RIVERS PHASE II

Final Environmental Impact Report

SCH 2005042018

April 2006

FIGURE 3-3
Vesting Tentative Subdivision Map

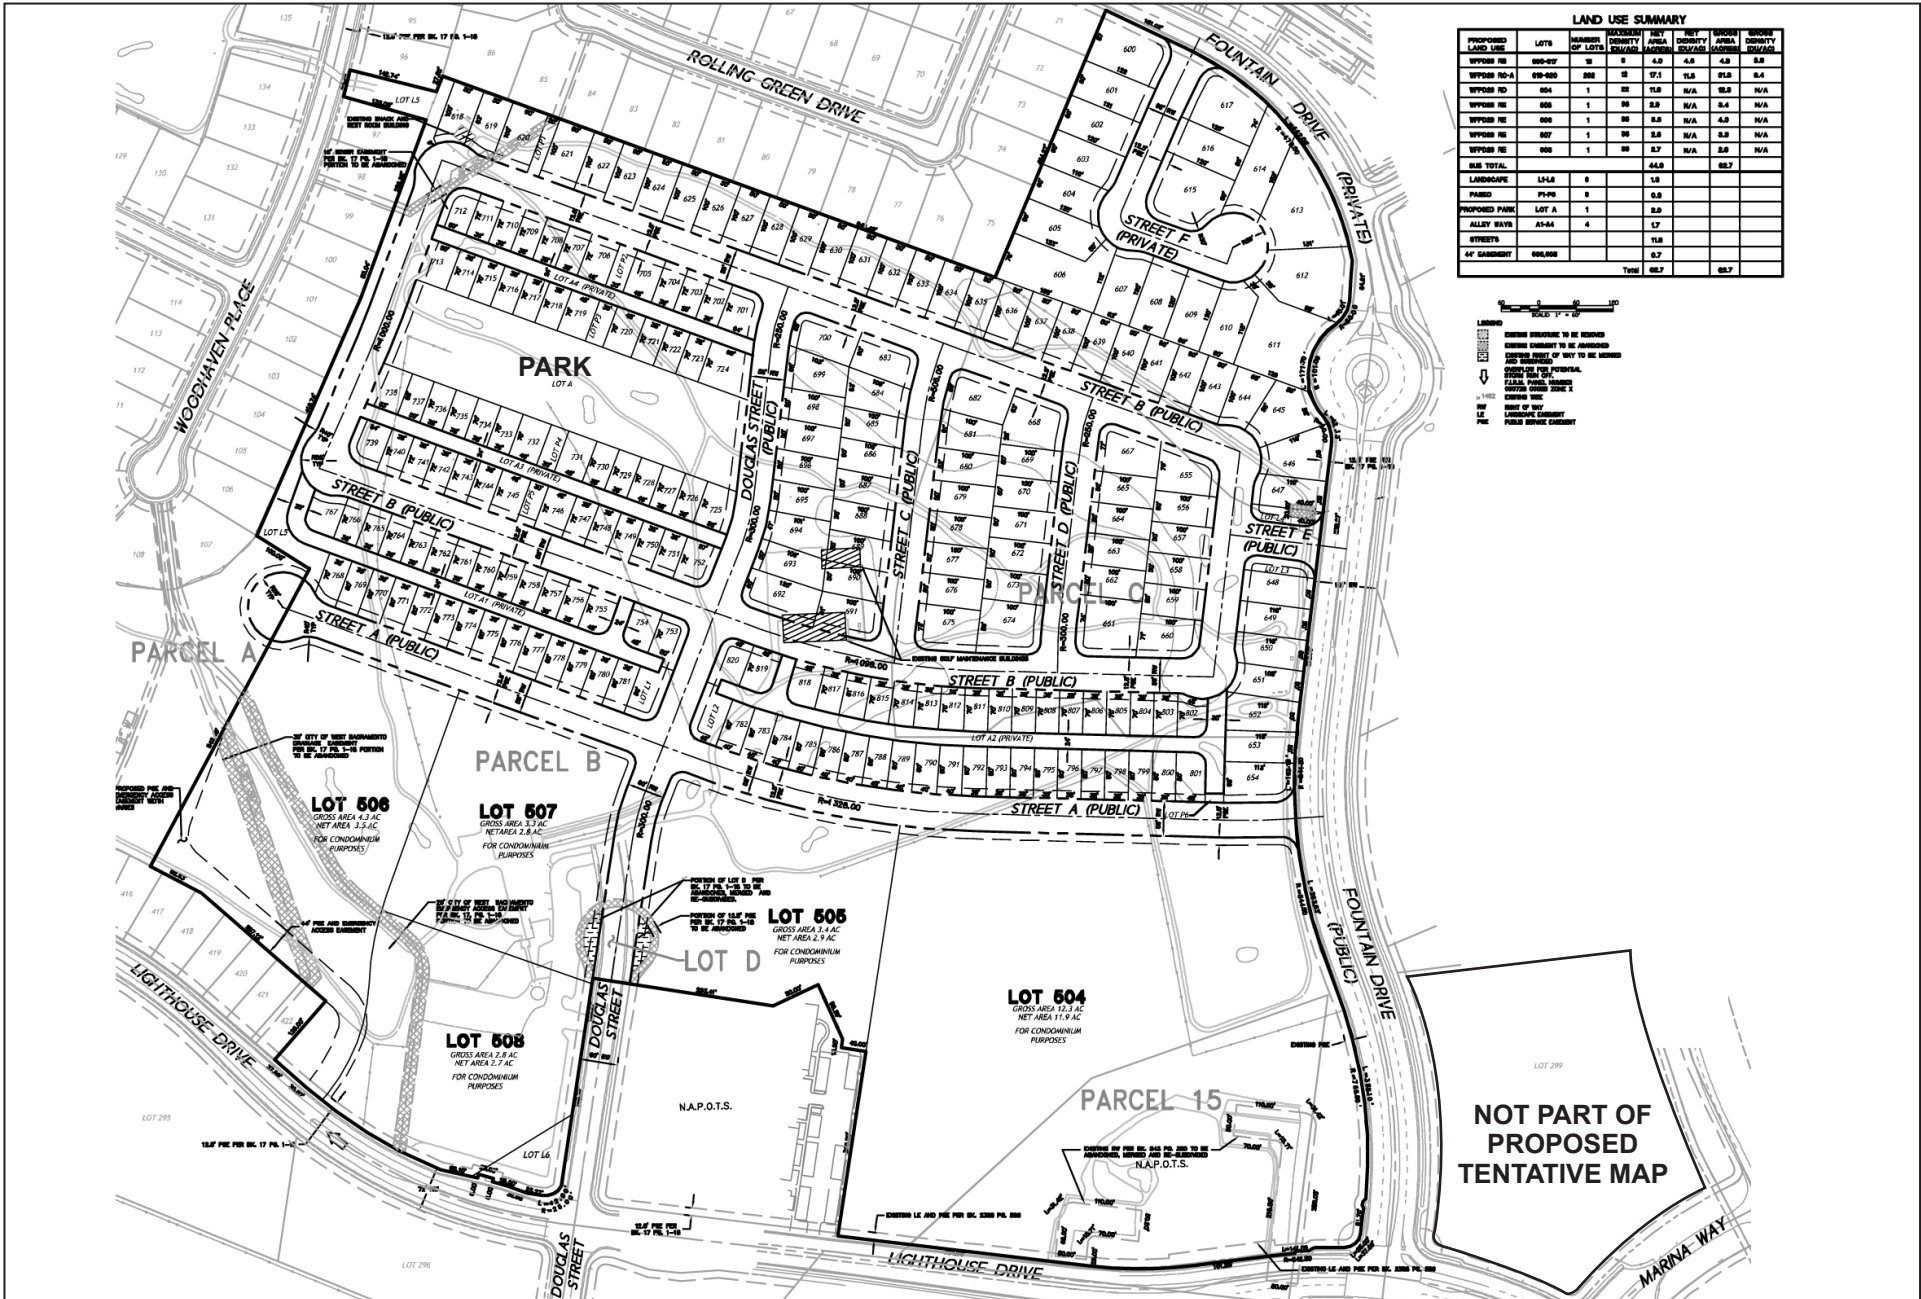
Figure 3-3, Vesting Tentative Subdivision Map, on page 3-7 of the Draft EIR is revised to note that the lots designated RD and RE single-family attached units would be developed as condominiums. This does not change the conclusions of the Draft EIR. The revised figure is included at the end of this chapter.

FIGURE 3-8B
MBK Levee Typical Cross Section

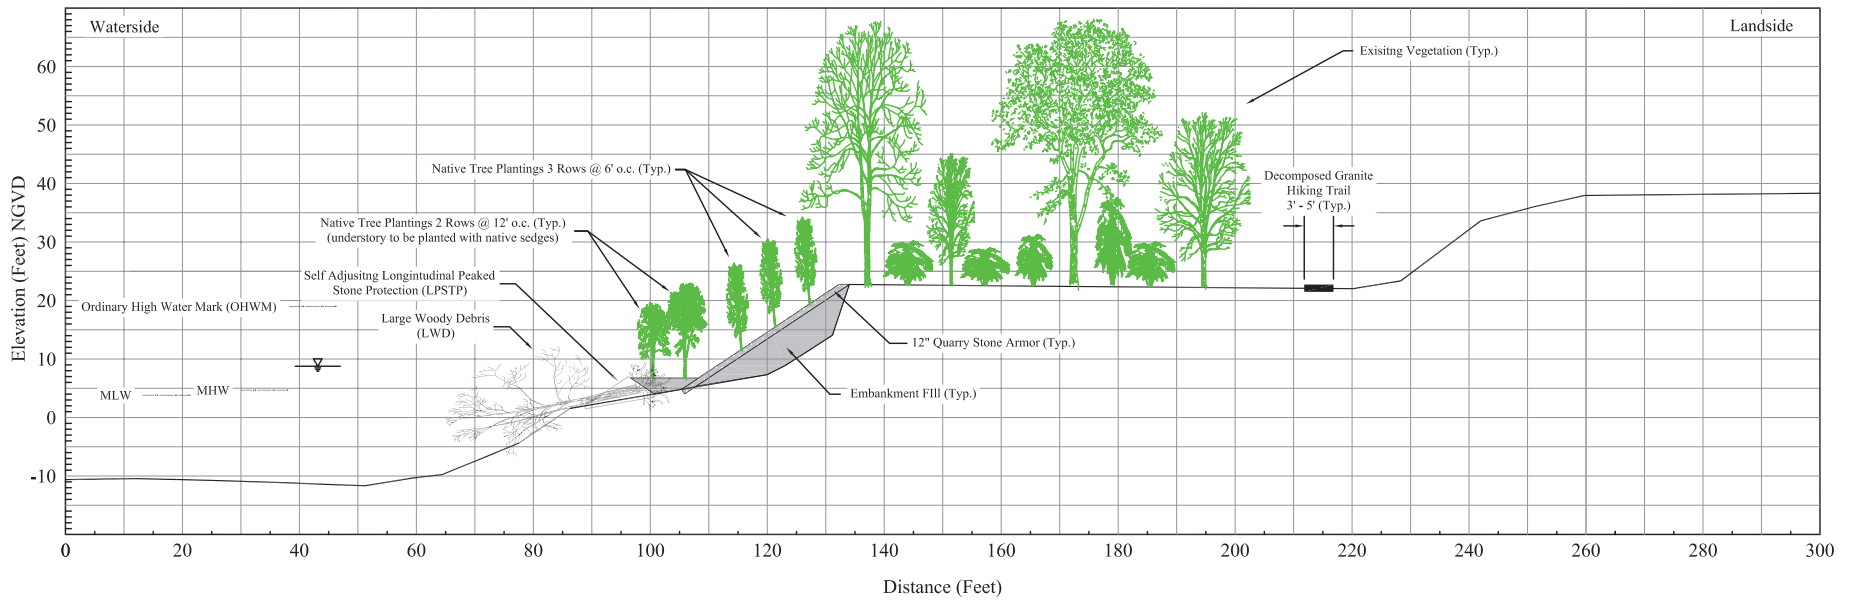
Figure 3-8, MBK Levee Typical Cross Section, on page 3-16 of the Draft EIR has been revised to include the proposed informal hiking trail and is included at the end of this chapter. In addition, the figure numbers are revised and the new figure numbers are 3-8a and 3-8b.

FIGURE 4.6-1
Existing PD-29 Designations

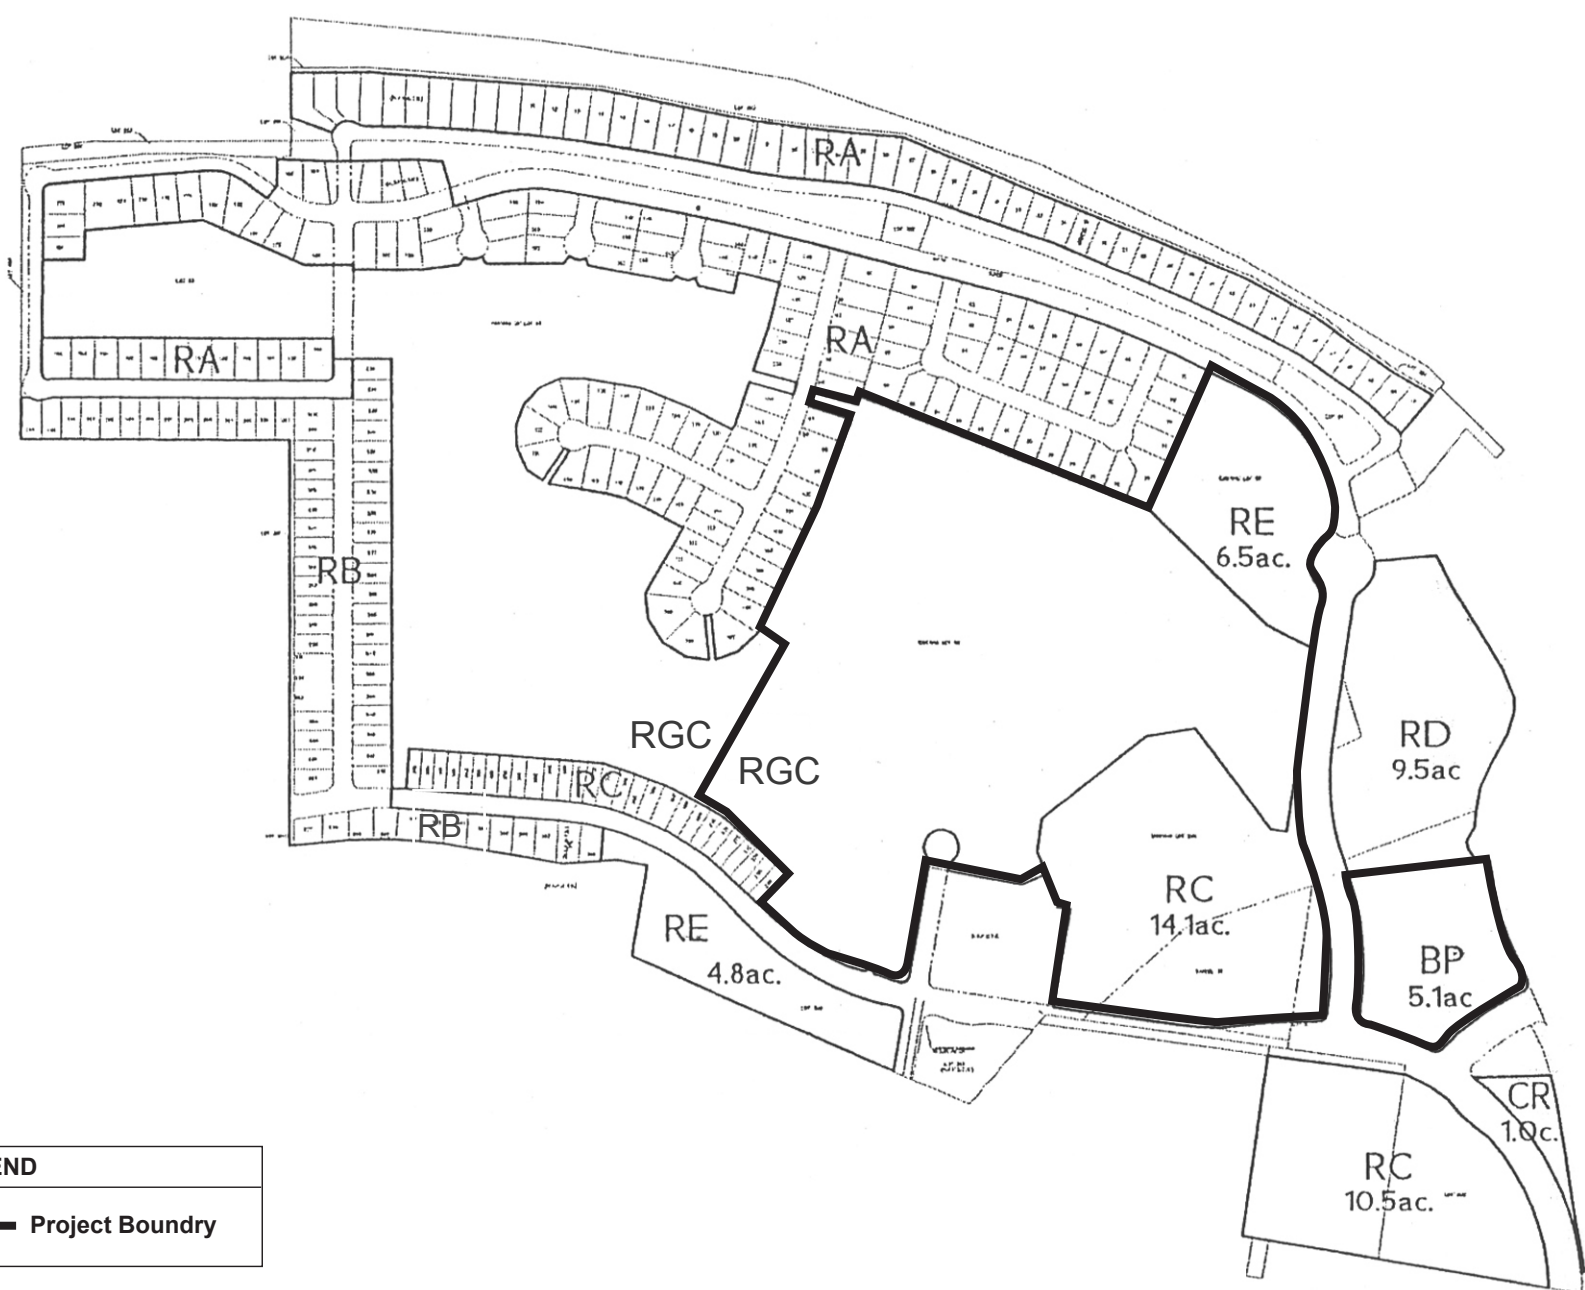
Figure 4.6-1, Existing PD-29 Designations, is revised to show the RB designation in the southeast portion of the site. Additionally, the BP/CR designation is changed to BP. The revised figure is included at the end of this chapter.
